# COLORADO GEOLOGICAL SURVEY

**Subject: Calwood Fire Emergency**

**Boulder County, CO;  
County Technical Aid Request; CGS Unique No. BO-21-0002**

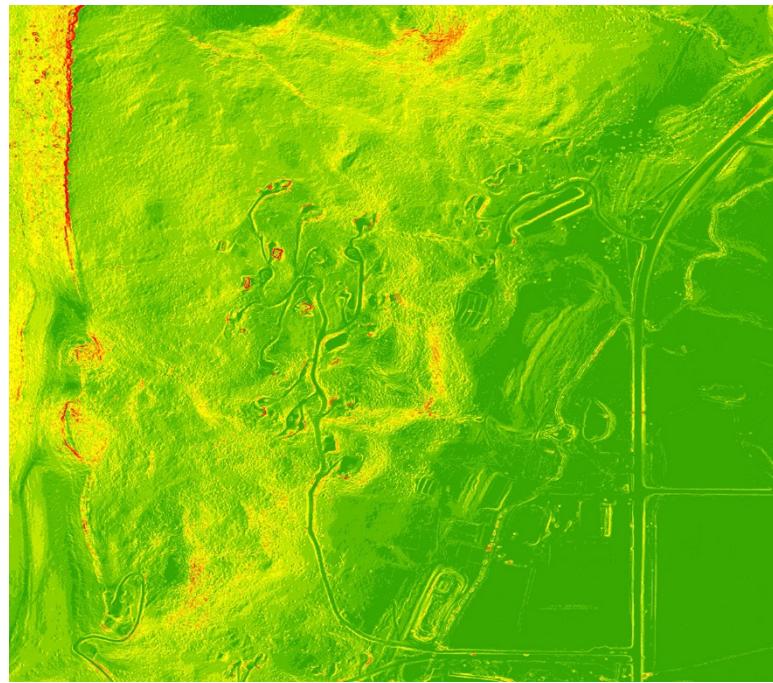
- in landslide susceptibility zones as defined by Boulder County Geologic Hazard mapping; and,
- were constructed in a previous landslide deposit as depicted in the published (1988) geologic map of the Lyons Quadrangle (1:25 000 scale). The geologic map depicting the landslide deposit is overlain on Lidar imaging in Figure 1.

We did not observe any features related to the fire that would indicate any change in the landslide susceptibility at these locations. The geomorphology of the ground has not been significantly altered by the fire event. However, these locations remain susceptible to landslides and the water and grading recommendations by CGS in 1988 (limited irrigation; limited cuts and fills) remain valid.
